Harbor Cleanup News

New Bedford Harbor ❖ February 2002

Changes Proposed to Harbor Cleanup Plan

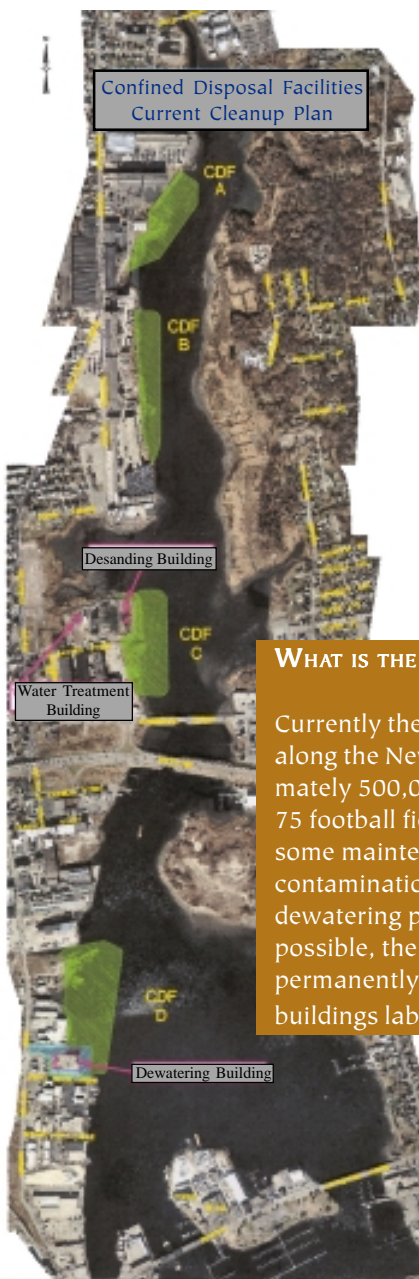
- ◆ Eliminate the construction of a 17-acre confined disposal facility along the north terminal area of New Bedford harbor, and instead, build a 2-acre facility to support dewatering activities and off-site transportation.
- ◆ Dispose, off-site, contaminated sediment originally slated for the confined disposal facility.

Why is EPA Proposing to Dispose of the Contaminated Sediment Off-Site Rather than Build the 17-Acre Confined Disposal Facility (labelled CDF D on the photo)?

One: Constructing a confined disposal

facility along the harbor's north terminal area (labelled CDF D on photo) poses difficult and costly engineering challenges.

Sediment borings showed weak and silty sediment. That existing soft sediment would have to be dredged and replaced

with structural fill to make sure the confined disposal facility's foundation would be strong enough. Approximately 300,000 cubic yards of the weak sediment, or 45 football fields each filled 3 feet high, would need to be removed and disposed; greatly adding to the cleanup cost and total amount of sediment needing disposal.

Three: To support the off-site transportation options and to provide for a bulkhead for the dewatering activities, only 2 acres would need to be filled instead of the 17 acres needed for the confined disposal facility. Filling 15 less

acres of tidelands would have less impact on the harbor's aquatic habitat.
